Bid 639
New HVAC Modernization Project for Pacifica High School

BID CLARIFICATION ADDENDUM #1

Dated: October 18, 2020

DRAWING NUMBER: **AE3.3**

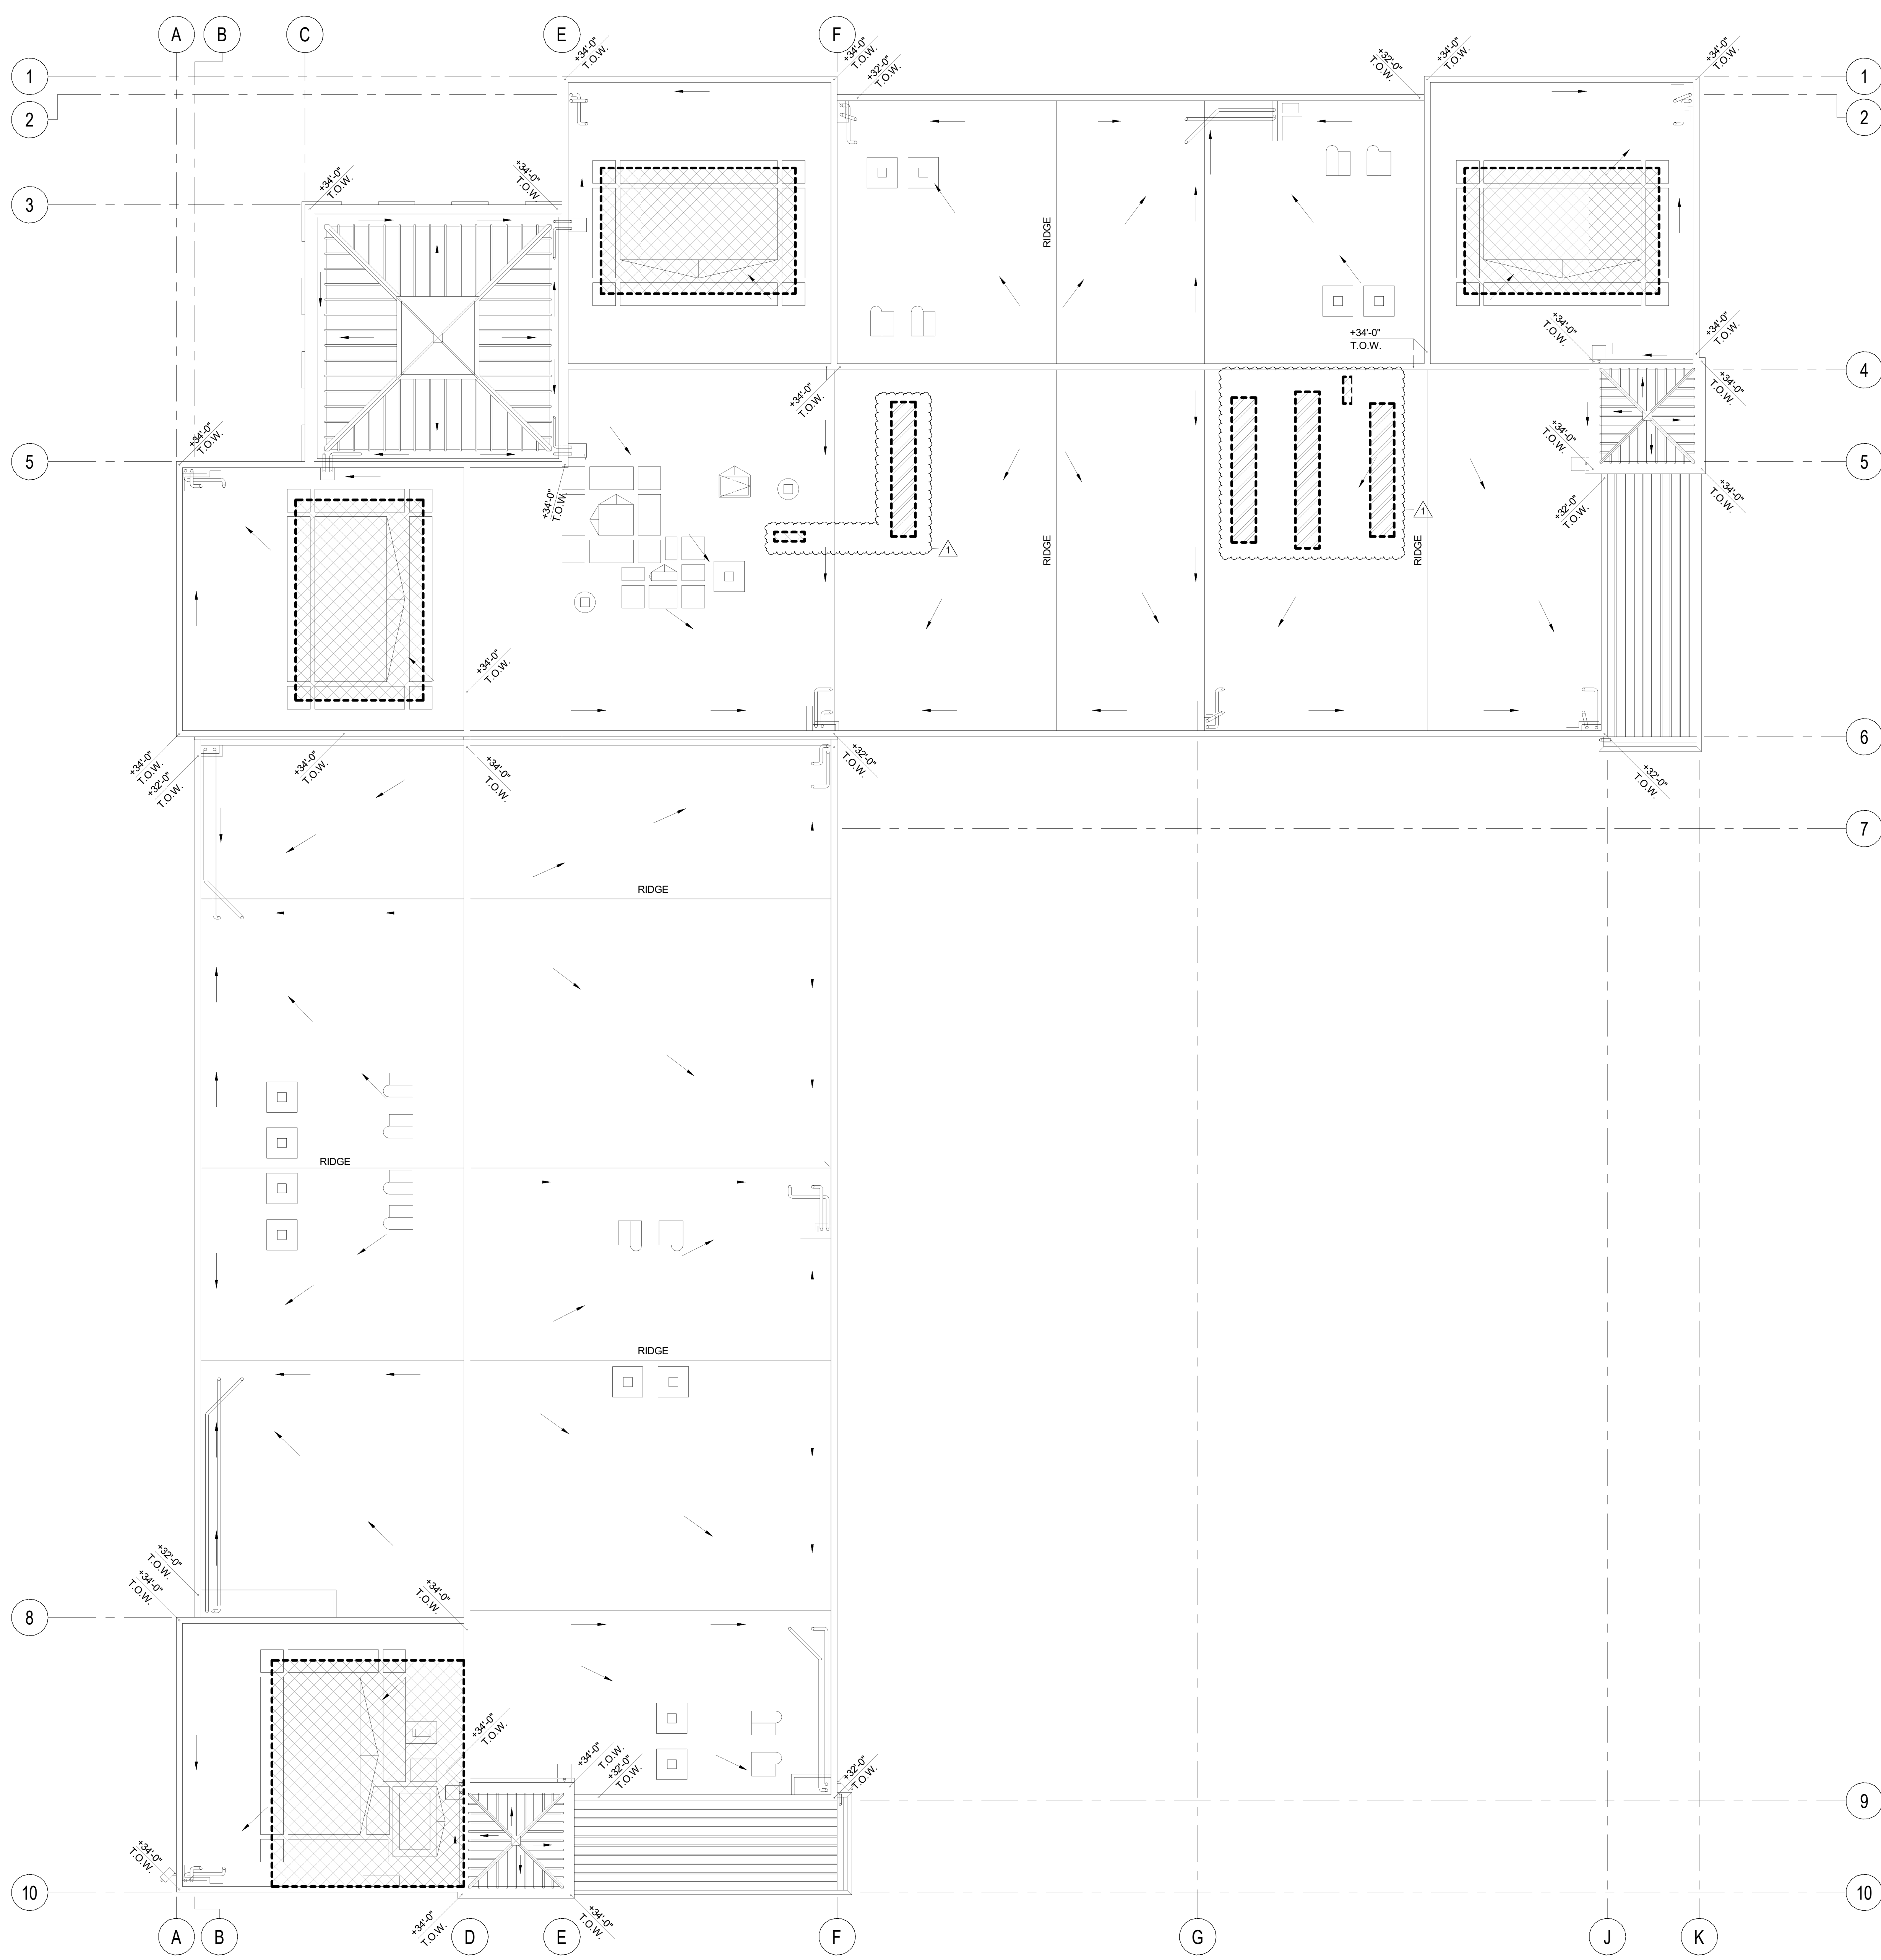
1.28 DRAWING AE3.3 - NEW SECOND FLOOR CEILING PLAN - BLDG E

- A. Replace DSA approved Drawing AE3.3 in its entirety with the attached revised Drawing AE3.3. (Additional ceiling tiles required replacement)

NEW ROOF PLAN - BLDG E

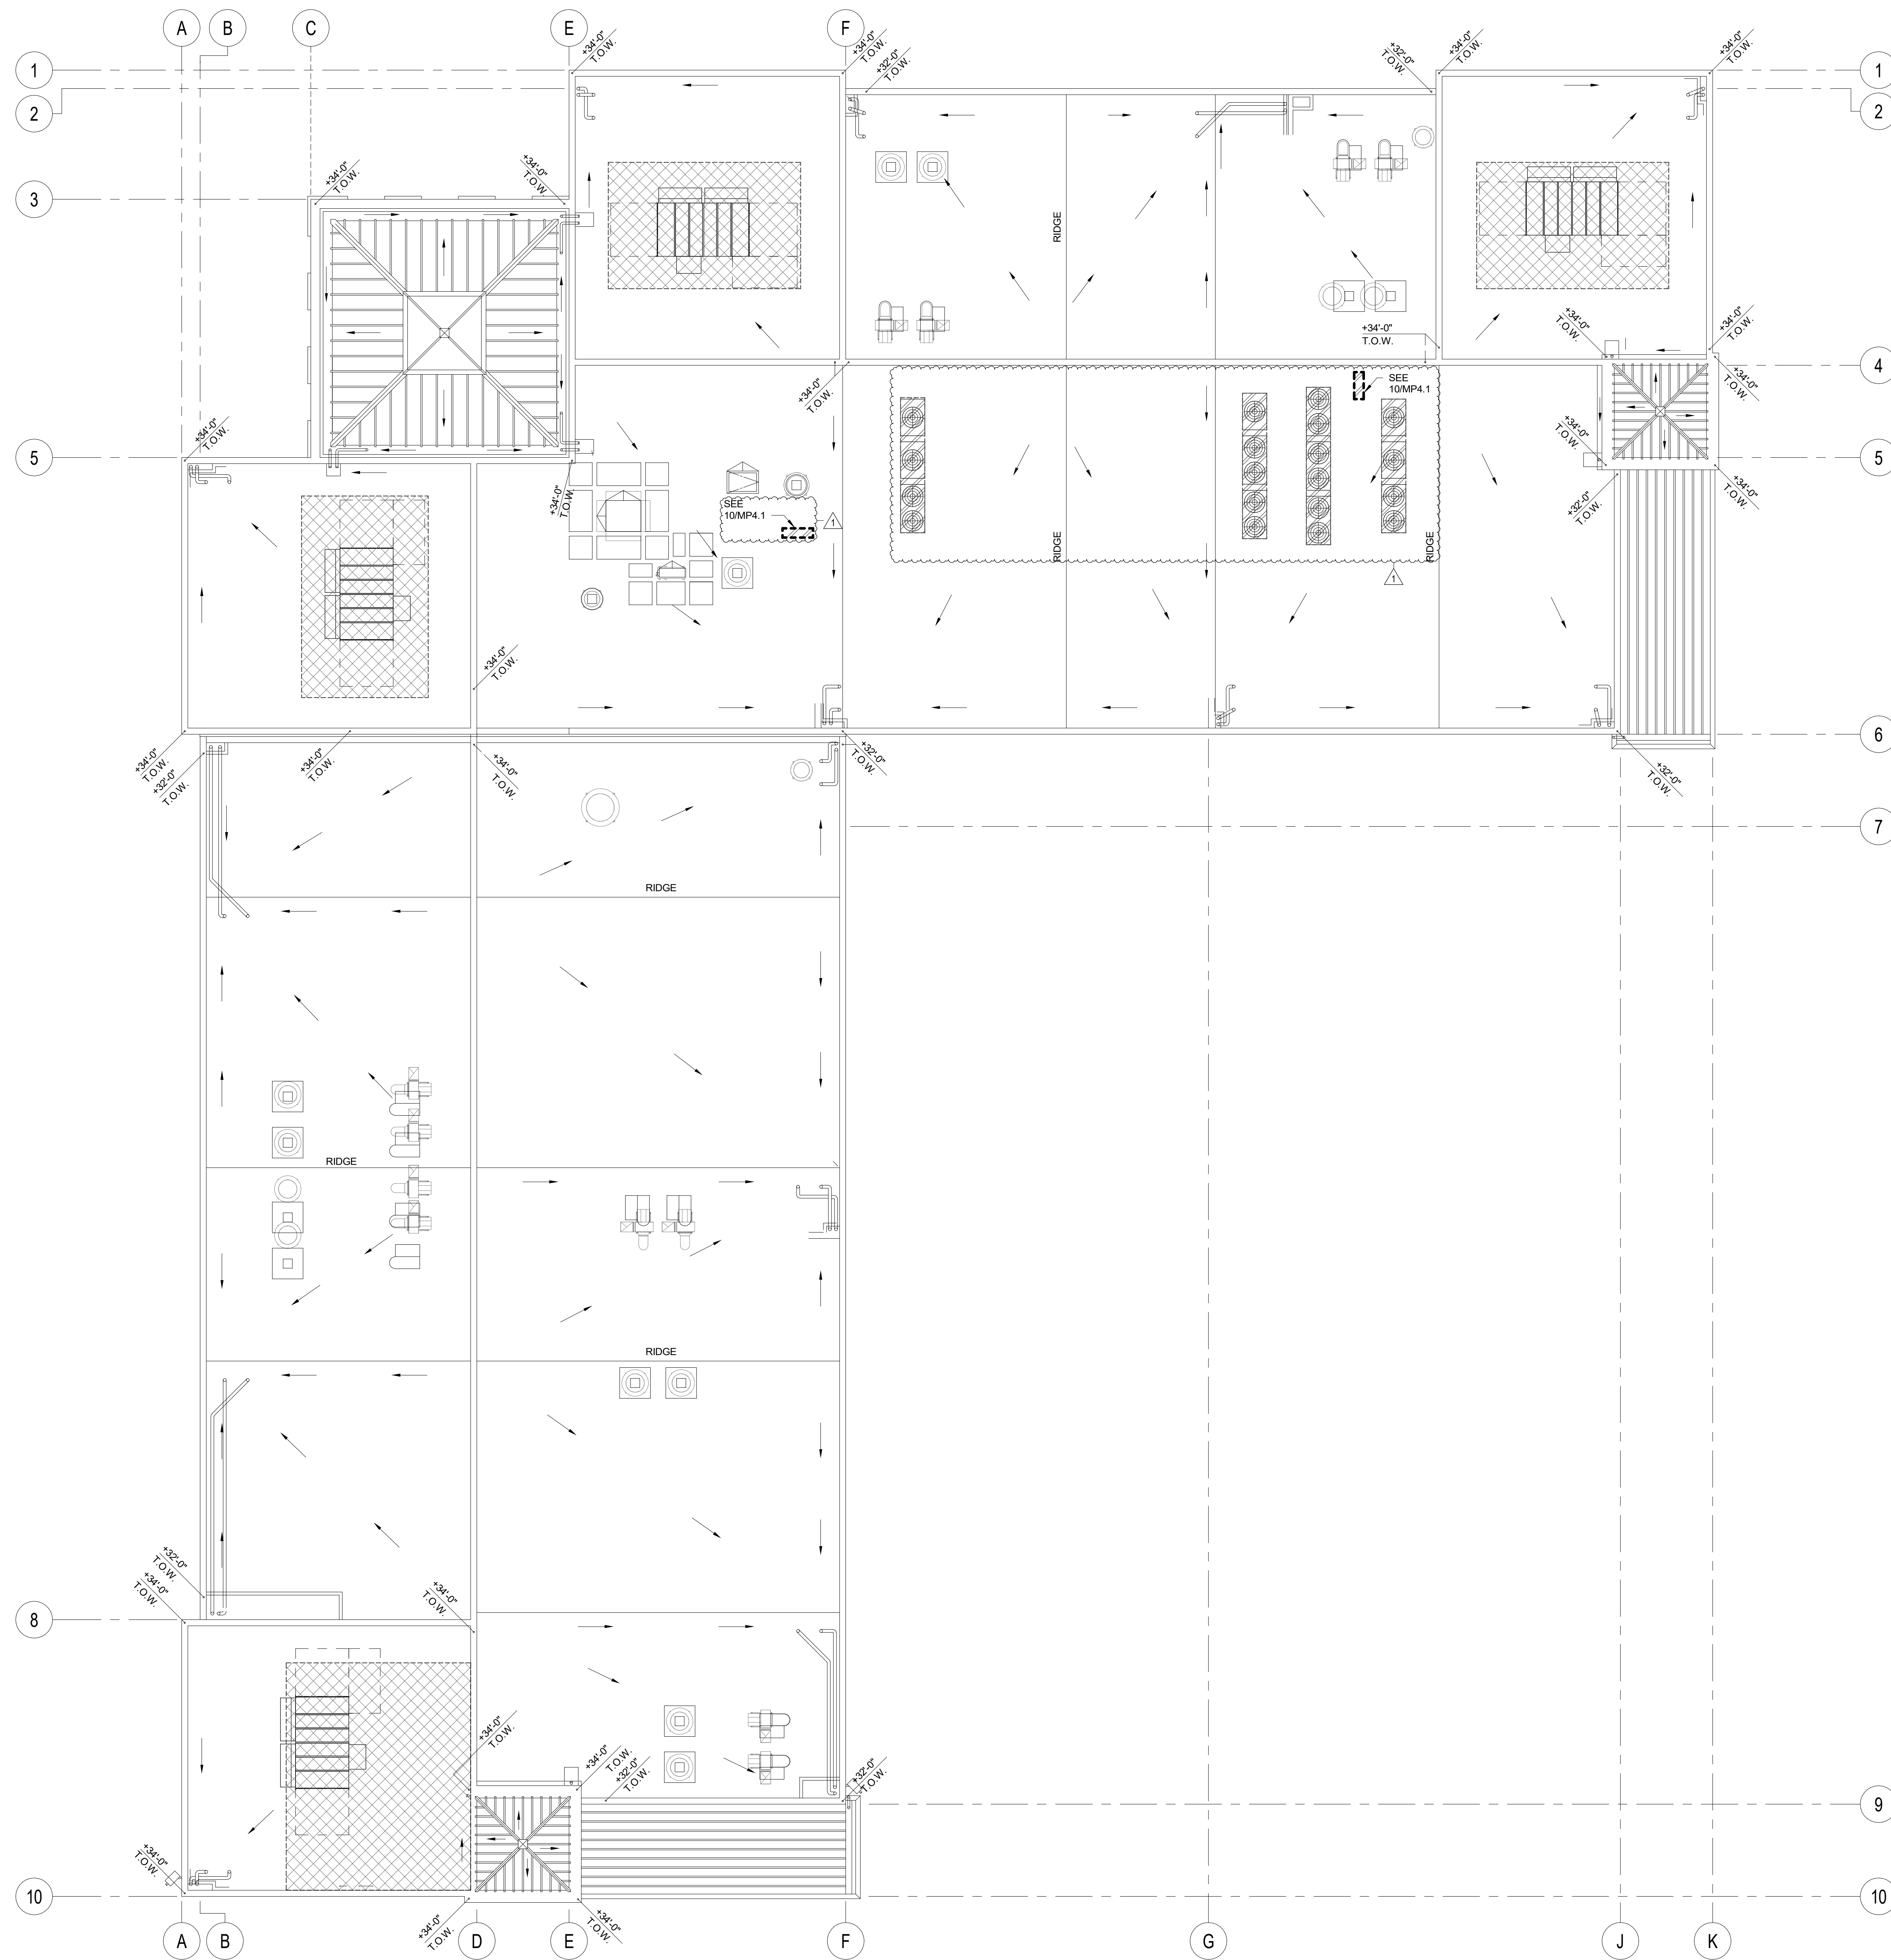
1.30 DRAWING AE4.1- NEW ROOF PLAN - BLDG E

- A. Replace DSA approved Drawing AE4.1 in its entirety with the attached revised Drawing AE4.1. (New equipment was relocated on the roof and added new text to legend note)

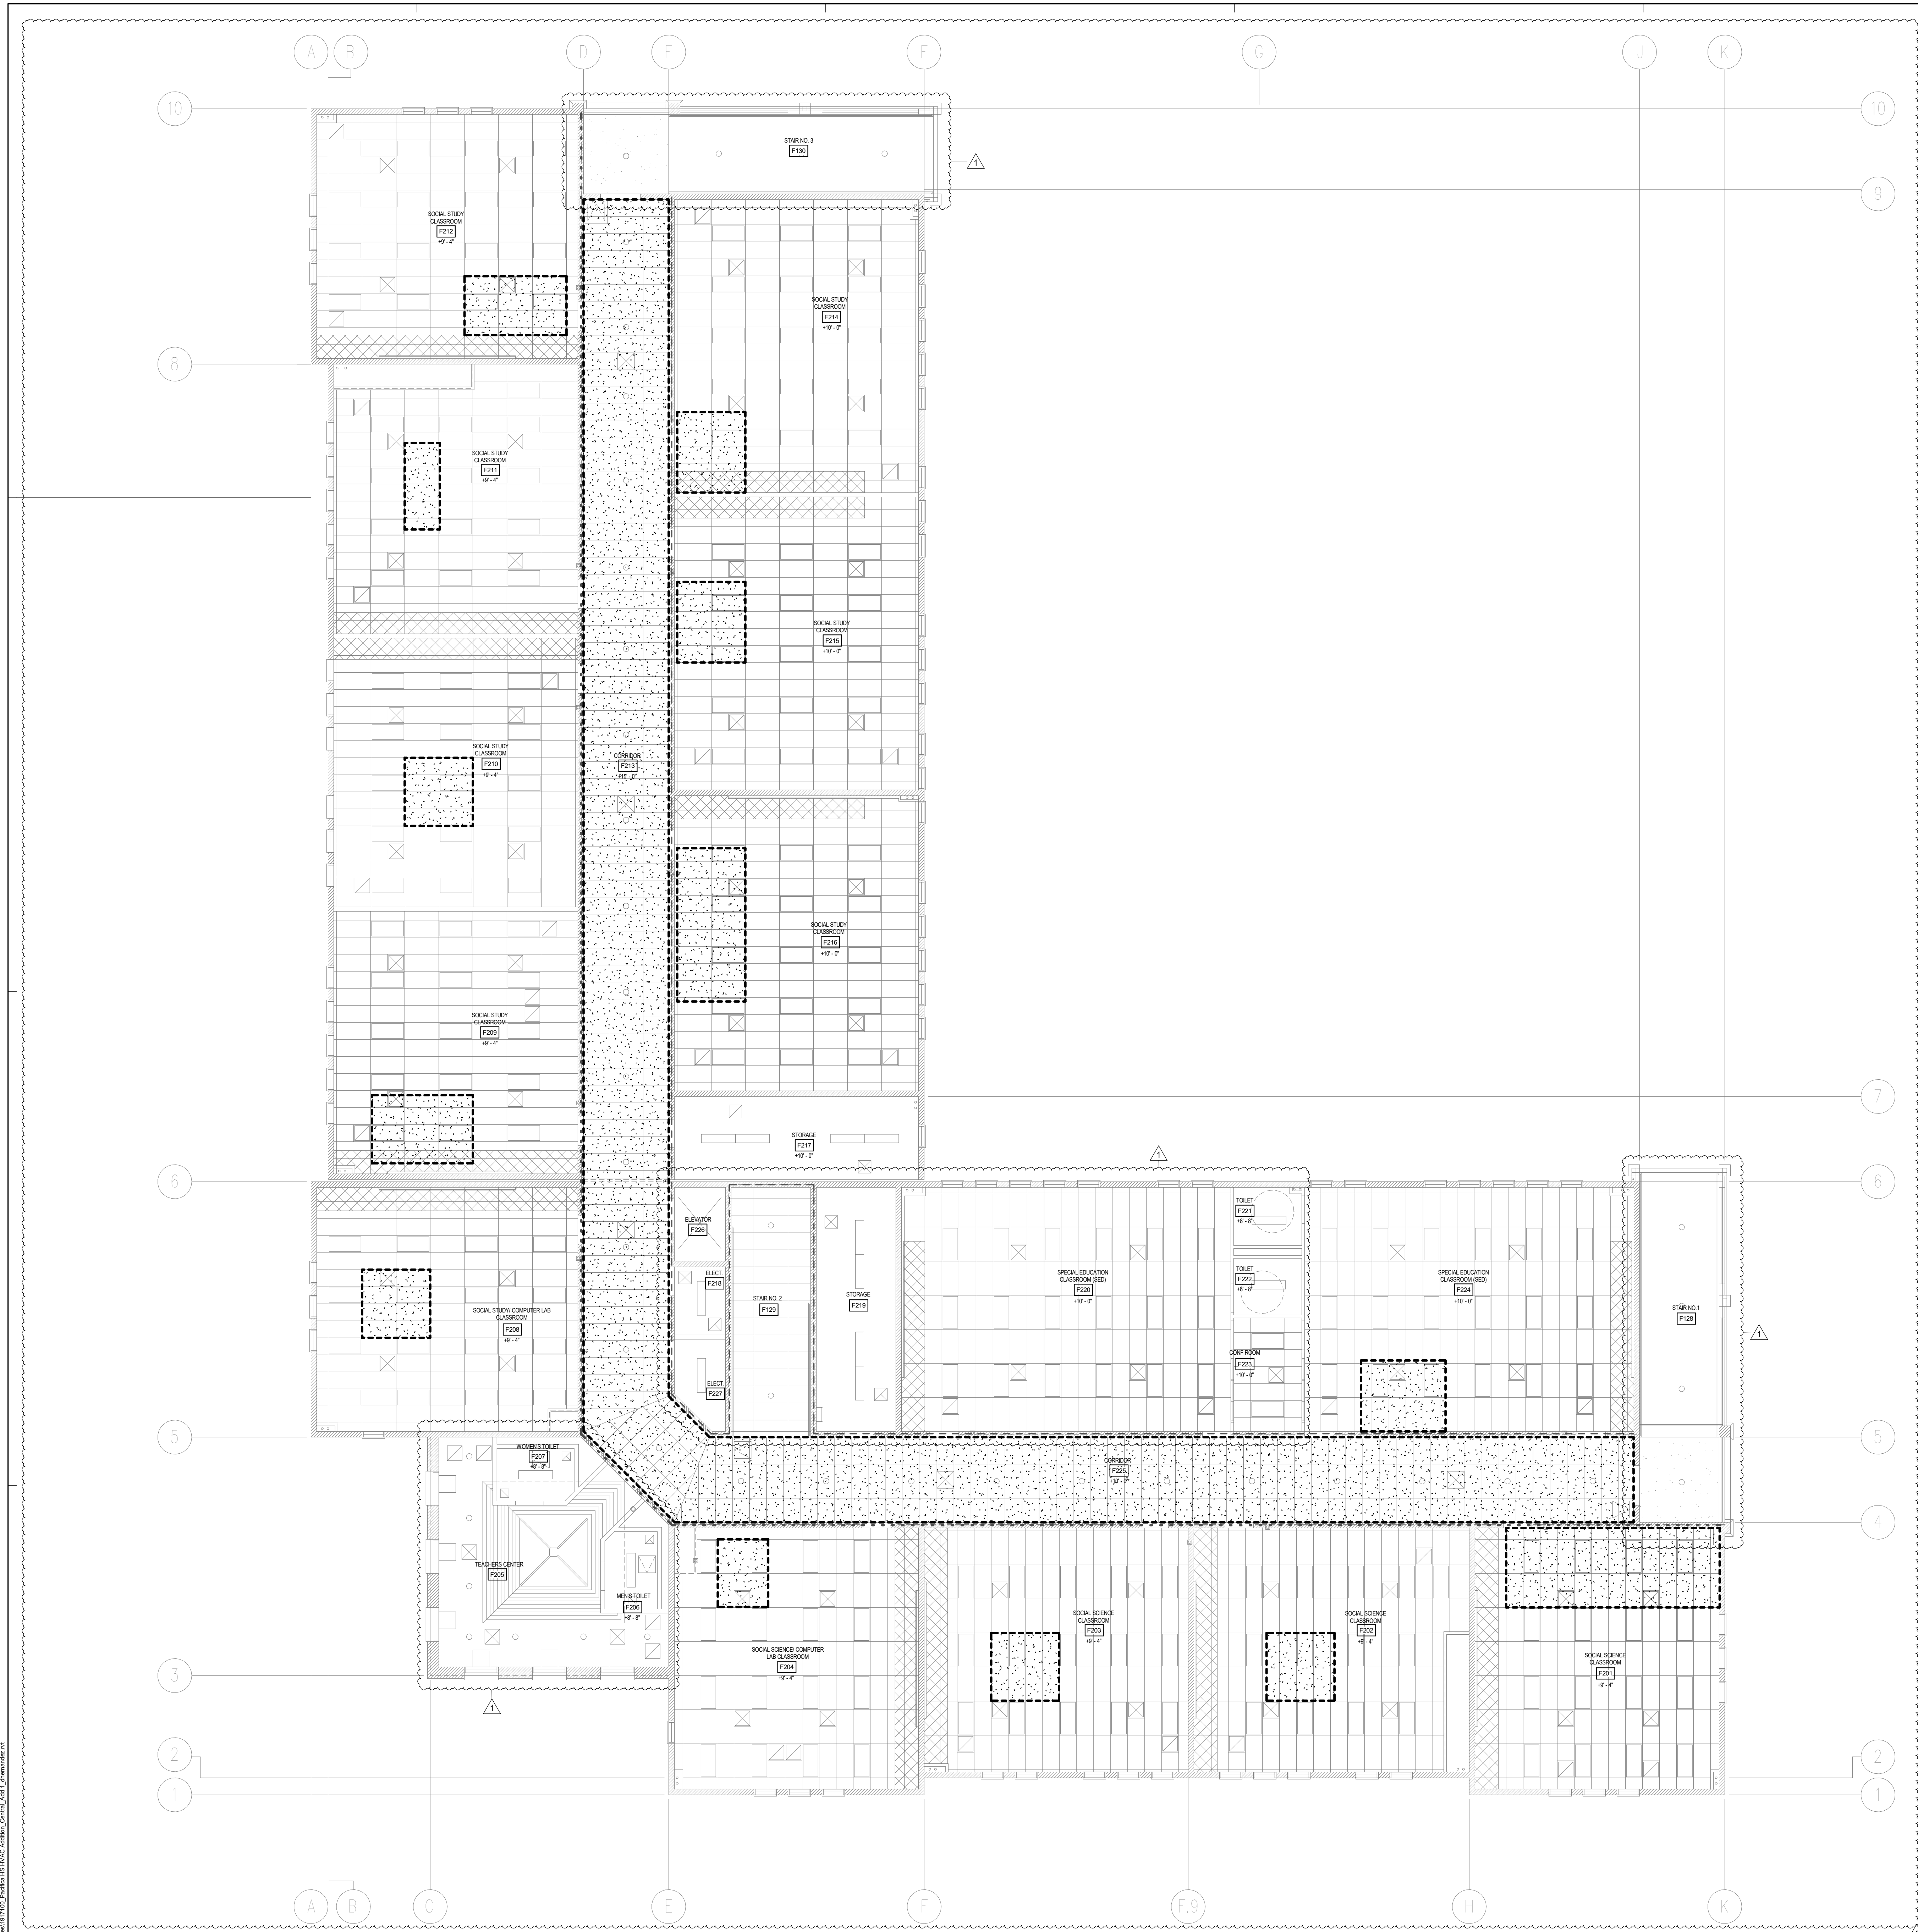
1.31 DRAWING AF3.0 DEMO CEILING PLAN - BLDG F

- A. Replace DSA approved Drawing AF3.0 in its entirety with the attached revised Drawing AF3.0. (VRF plumbing has been relocated, so we had to adjust the removal of ceiling tile locations.)
